No.	REVISION/DESCRIPTION	BY	DATE
1	ISSUE FOR ADDENDUM 1: ADDED NOTE 14 & 15	JKR/DTA	2017.12.04
0	ISSUE FOR CONSTRUCTION	DTA	2017.11.15

PROJECT
WINNIPEG FIRE PARAMEDIC SERVICES
STATION No.16
INTERIOR RENOVATIONS
1001 MCGREGOR STREET BID OPP: 1013-2017

SHEET TITLE
BASEMENT AND MAIN FLOOR PLANS
RENOVATION

SCALE	PROJECT No:	SHEET No:
AS SHOWN	2016-009	A1R1

MAIN FLOOR PLAN
SCALE: 1/8" = 1'-0"

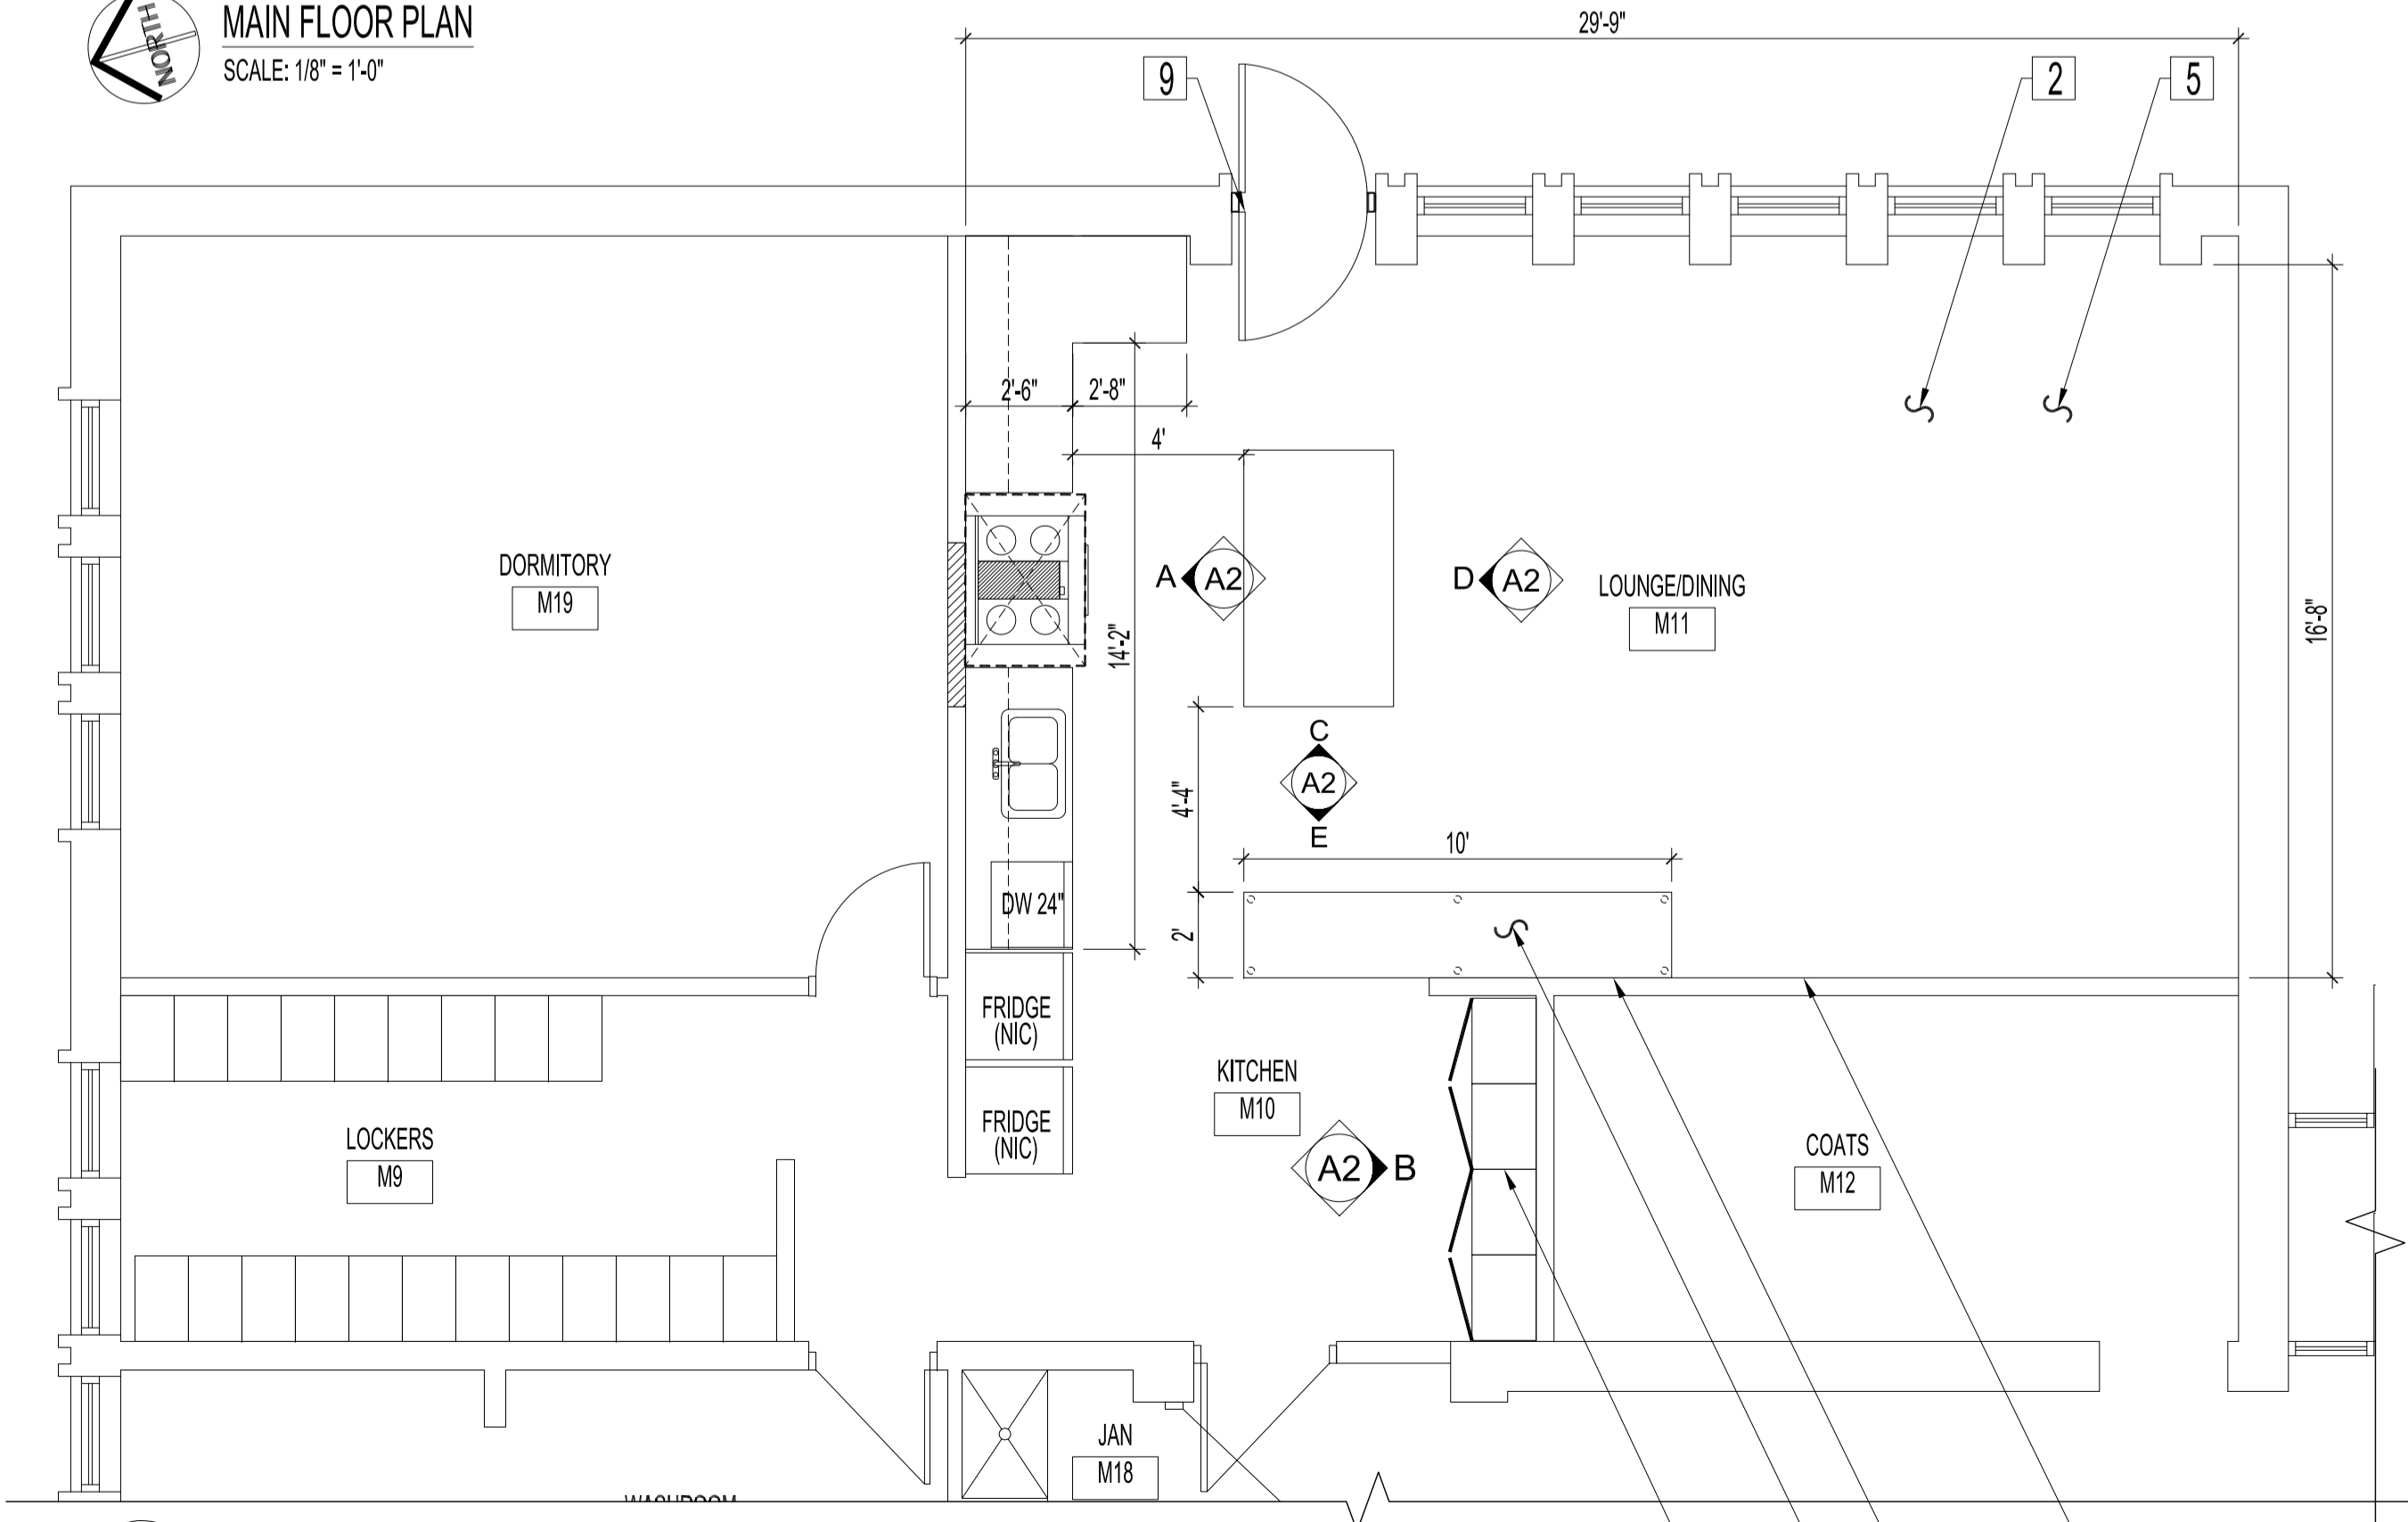
- 14. REPLACE WINDOWS SHOWN WITH WINDOW TYPES. SEE DRAWING A3 FOR WINDOW TYPES.
- 15. PROVIDE NEW BLINDS ONLY IN KITCHEN AREA. SEE DRAWING A3.
